BETTERGROW WETHERILL PARK

Modification of the Bettergrow Resource Recovery and Recycling Facility

Response to Submissions

SSD 7401 – MOD1

Figure 1 1:100 Flood Level (Green Shading)

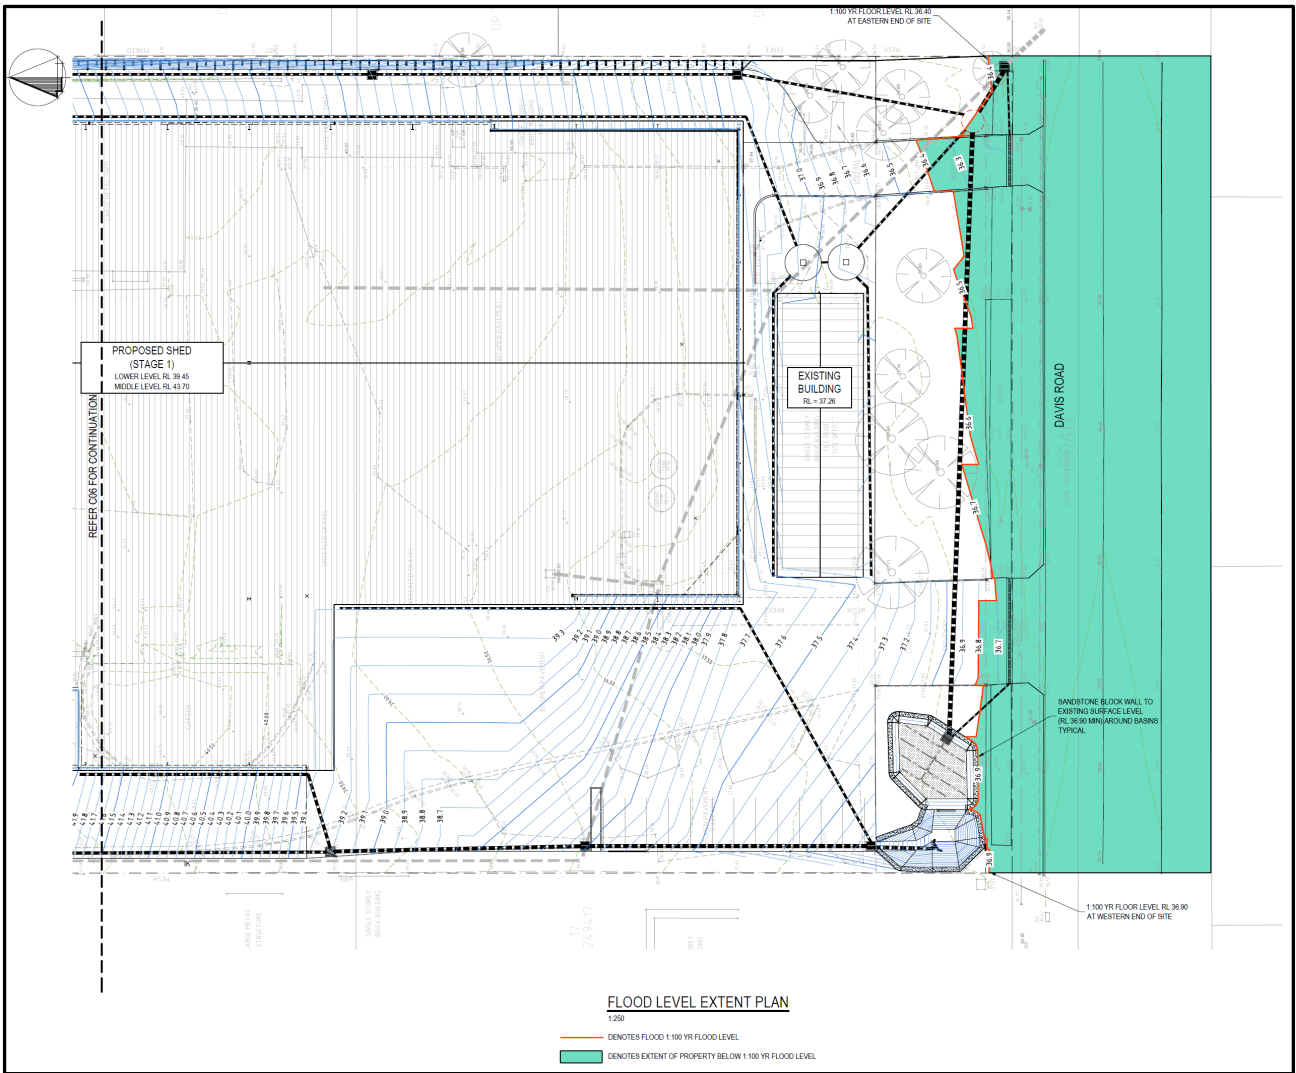
Clarify whether any structures are below the 1 in 100 flood level, include the onsite detention basin on the south-west corner of the site.

A Flood Information Sheet has been provided by Fairfield City Council for this site. This provided the flood level information of 1:100 Year Flood Level ranges between 36.9 - 36.4 m AHD.

The extent of the above 1:100 year flood level has been plotted on the proposed site plan below (**Figure 1**)

As can be seen from Figure 1, the 1:100 Year flooding extent does not encroach on any of the existing or proposed building or within the proposed on-site detention basin or the bioretention basin.

Figure 2: Location of Industrial Receptors

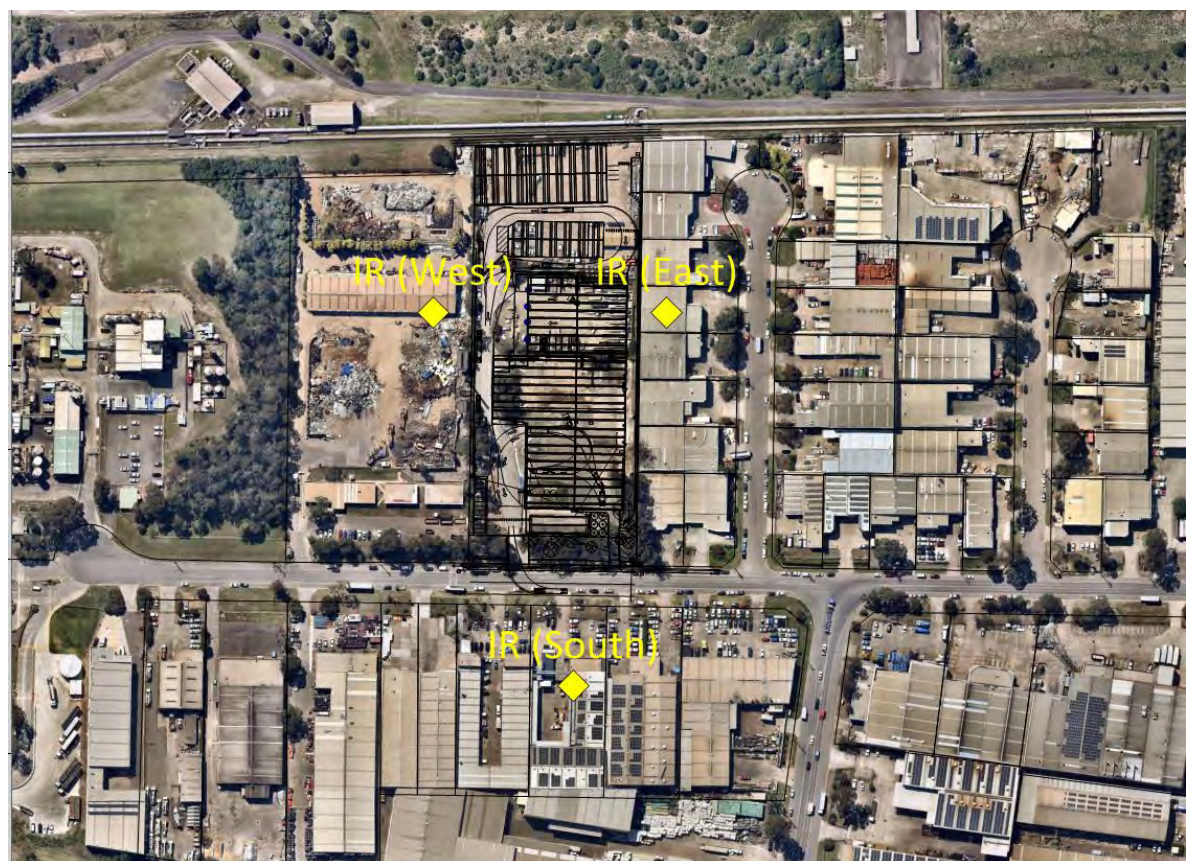
The Dust Assessment appears to compare the development in isolation against the air quality assessment criteria. Further detail on the potential cumulative dust impacts at industrial receivers is required. The background data showed the maximum 24-hour average concentration of PM10 during 2013 and 2015 exceeded the goal of 50 µg/m3. Provide details on the dust mitigation measures proposed to address any potential cumulative dust concentrations which exceed the assessment criteria.

Presented in Figure 2 is the location of the Industrial Receptors for which a detailed cumulative impact assessment has been undertaken. Note that the receptors to the east and to the west are in closest proximity to potential dust generating sources which are located in the middle section of the facility.

A summary of the predicted cumulative impacts for the 24 hour average concentration of PM_{10} at the location of the three Industrial Receptors indicated in Figure 2 is provided in Table 1.
